Access Compliance Report Public Rights-of-Way (Curb Ramps)

Main Street: RIBERA_RD Cross Street: CONTIGO_PL Location: NW

ADA ID: RPRK211117163932 Ramp Type: Type 4 - Parallel Initial Pass/Fail: Pass Overall Compliance: No Severity Score: 5

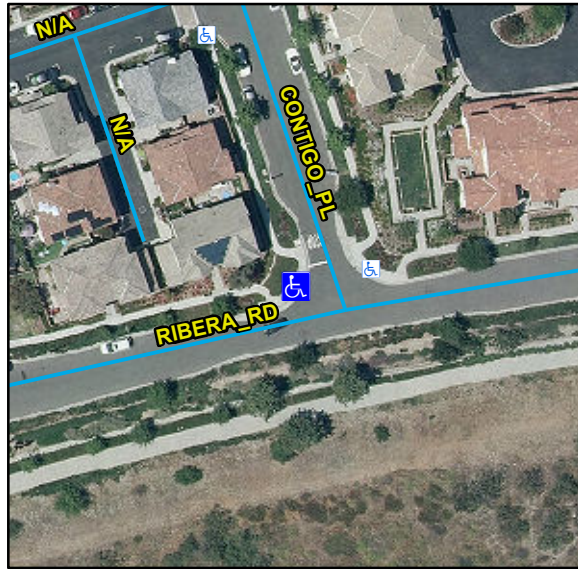
Compliance	Description	Data	Compliance	Description	Data
N/A	Ramp Length LT (in)	119	N/A	Ramp Length RT (in)	112
Yes	Ramp Width LT (in)	54	Yes	Ramp Width RT (in)	54
Yes	Ramp Run Slope LT (%)	3.4	Yes	Ramp Run Slope RT (%)	5.6
Yes	Ramp Cross Slope LT (%)	1.5	Yes	Ramp Cross Slope RT (%)	1.3
N/A	Landing Present	Yes	Yes	DWS Provided	Yes
N/A	Landing Length (in)	54	Yes	DWS Contrast	Yes
Yes	Landing Width (in)	48	Yes	DWS Length (in)	36
Yes	Landing Run Slope (%)	1.3	Yes	DWS Full Width	Yes
Yes	Landing Cross Slope (%)	0.6		DWS Offset Type	Single
N/A	Landing Movement Obstructed?	No	Yes	DWS Offset Left (in)	0
	Landing Movement Type	Curb	Yes	DWS Offset Right (in)	N/A
N/A	Landing Shared	No			
N/A	Clear Space	Yes			
N/A	Clear Space To Crosswalk (in)	48			
N/A	Marked Crosswalk 1	No	N/A	Marked Crosswalk 2	No
	Crossing 1 Direction	S		Crossing 2 Direction	E
	Marked Crosswalk 1 Width (in)	N/A		Marked Crosswalk 2 Width (in)	N/A
N/A	Ramp Inside Crosswalk 1	N/A	N/A	Ramp Inside Crosswalk 2	N/A

Crossing 1 Slope (%)	1.9		Crossing 2 Slope (%)	0.8
	Crossing 1 Cross Slope (%)	1.4		Crossing 2 Cross Slope (%)	0.2
Yes	Gutter Ponding	No	No	Curb Slope	8.7
Yes	Gutter Lip Height (in)	0		Road Run Slope (%)	0.7
No	Gutter Run Slope (%)	6		Road Cross Slope (%)	1.1
Yes	Gutter Cross Slope (%)	0.6	Yes	Perpendicular Joint Present	Yes
Yes	Overall Surface Condition	Acceptable			
	Cross Gutter Present?	No		Spandrel Present?	No
	Replace Cross Gutter?	N/A		Replace Spandrel?	N/A

Remove & Replace Curb Slope. Remove & Replace Gutter.

R304.2.2, R304.5.4, STD 1115
